STAFF REPORT
COMMUNITY DEVELOPMENT DEPARTMENT

HEARING DATE: December 14, 2021
 TO: Mayor & City Council
 FROM: Sonya Allen, Associate Planner
 208-884-5533
 SUBJECT: H-2021-0063 – Outer Banks Subdivision/The 10 Meridian
 LOCATION: SWC of W. Franklin Rd. & S. Ten Mile Rd., in the NE ¼ of Section 15, Township 3N., Range 1W. (Parcel: S1215110058)

Preliminary plat (PP) consisting of 25 buildable lots on 36+/- acres of land in the R-40 and C-C zoning districts for Outer Banks Subdivision; and a Conditional use permit (CUP) for a multi-family development containing a total of 516 residential dwelling units consisting of (364) high-density apartments, (126) flat and (26) townhome style units in the R-40 and C-C zoning districts for The 10 Meridian.

A. Preliminary Plat (date: 09/22/2021) & Phasing Plan – Revised Phasing Plan

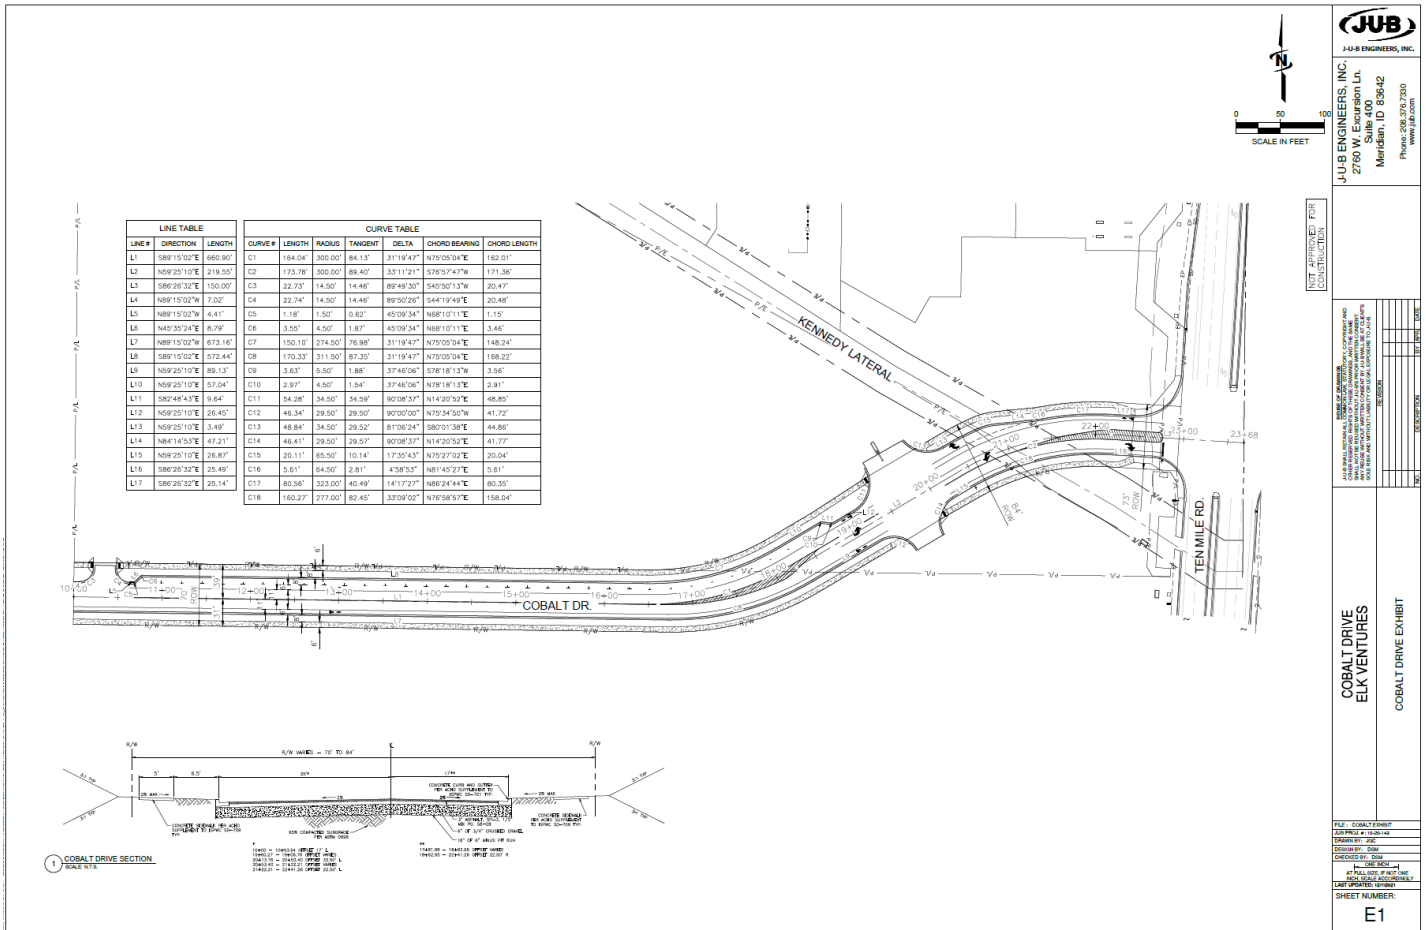
Two (2) full-access access driveways are proposed via W. Cobalt Dr. – one (1) 388' west of Ten Mile Rd. and one (1) at the site's west boundary. A cul-de-sac meeting Fire Dept. standards is required to be constructed at the terminus of the road. The Applicant has been working with the property owner to the south on the location and design of the portion of Cobalt Drive that's on their property (Parcel #S1215131400) (see road plan in Section VIII.B). A [Road Construction and Cooperative Development Agreement](#) has been signed by the two property owners in accord with the Development Agreement (provision #5.1f) but is in the process of being amended. The extension of Cobalt will be constructed prior to or with the first phase of development.

C. Landscape Plan for Preliminary Plat (dated: 9/16/24 12/6/2021) – REVISED

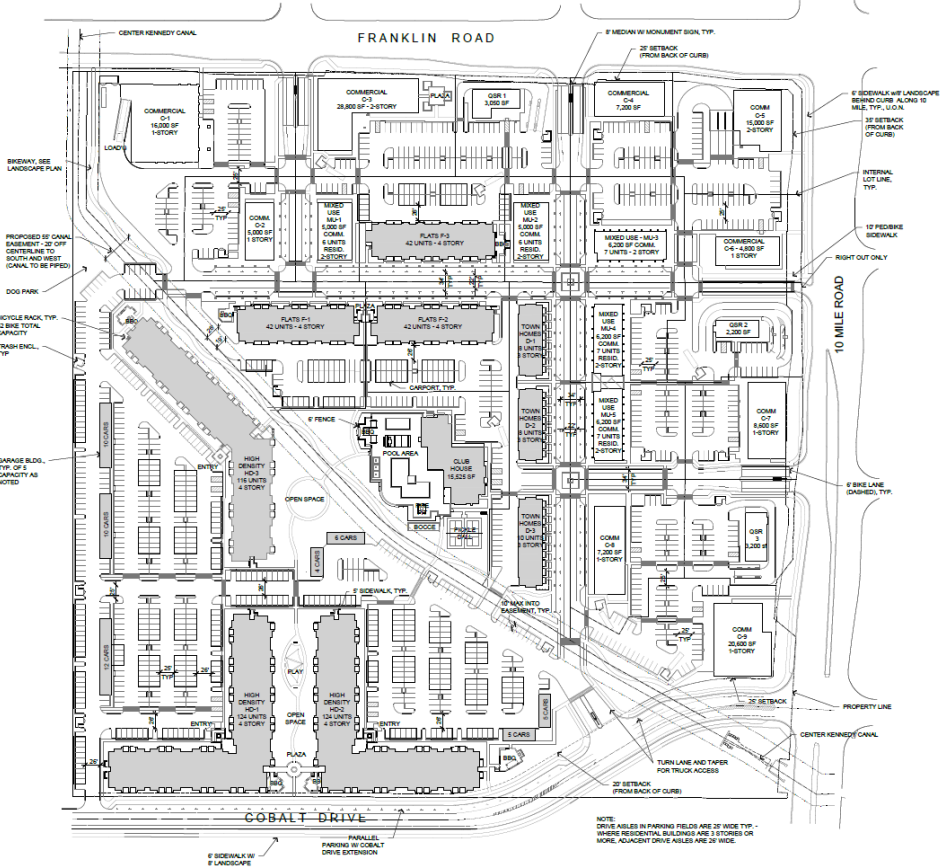
The number of trees proposed in buffers meets the minimum standard; however, a mix of trees and shrubs with lawn or other vegetative groundcover is required – shrubs should be added to the buffers in accord with UDC 11-3B-7C.3a. Tree lawns need to be provided along Franklin Rd., Ten Mile Rd. and Cobalt Dr. consistent with the TMISAP where not proposed.

Landscaping is required along all pathways per the standards listed in UDC 11-3B-12C, which requires a *mix* of trees, shrubs, lawn, and/or other vegetative ground cover – a minimum of one (1) tree per 100 linear feet of pathway is required. **The landscape plan should be revised accordingly to include shrubs along the pathway.**

3. The landscape plan included in Section VIII.C shall be revised as follows:
 - a. Include shrubs (along with the trees and lawn or other vegetative groundcover) in the proposed street buffers as set forth in UDC [11-3B-7C.3a](#) and along pathways as set forth in UDC [11-3B-12C.2](#).

- c. Include a calculations table on the landscape plan that demonstrates compliance with the landscape standards for street buffers listed in UDC [11-3B-7C.3b](#); common open space areas listed in UDC [11-3G-3E.2](#); and pathways listed in UDC [11-3B-12C](#).

D. Site Plan for Multi-Family Portion of Development (date: 8/23/2021 12/03/2021) - REVISED

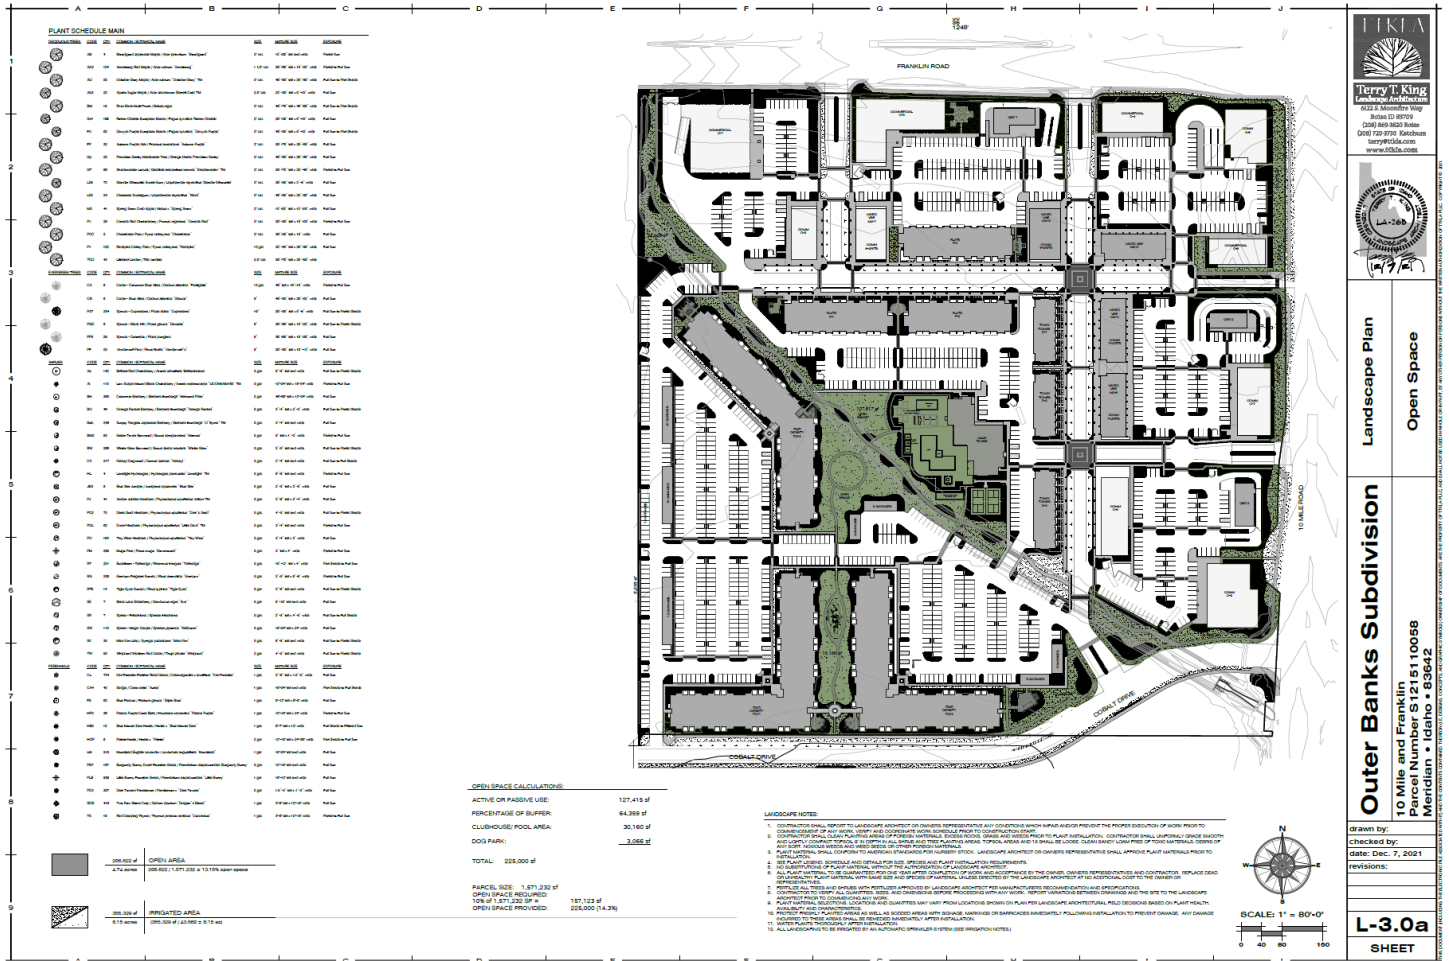
1. Buildings shall provide a minimum setback of ten feet (10') unless a greater setback is otherwise required by this title and/or [title 10](#) of this Code. Building setbacks shall take into account windows, entrances, porches and patios, and how they impact adjacent properties. *Flats F-3 and the garages along the west boundary do not meet the minimum setback requirement of 10'; revise accordingly.*

- c. A central mailbox location, including provisions for parcel mail, that provide safe pedestrian and/or vehicular access. *Depict on site plan.*
 - d. A directory and map of the development at an entrance or convenient location for those entering the development. (Ord. 18-1773, 4-24-2018) *Depict on site plan.*

The site plan submitted with the Certificate of Zoning Compliance application should depict the location of these items in accord with this standard.

- b. Depict the locations of the property management office, maintenance storage area, central mailbox location (including provisions for parcel mail, that provide safe pedestrian and/or vehicular access), and a directory and map of the development at an entrance or convenient location for those entering the development in accord with UDC 11-4-3-27B.7.

- d. The configuration/location of the Flats F-3 building and the garage structures along the project's west boundary need to be revised to comply with the minimum setback requirement of 10-feet in UDC [11-4-3-27B.1](#); the configuration of Lot 16 may be revised on the plat in order for the building (i.e. F-3) to meet the required setback.
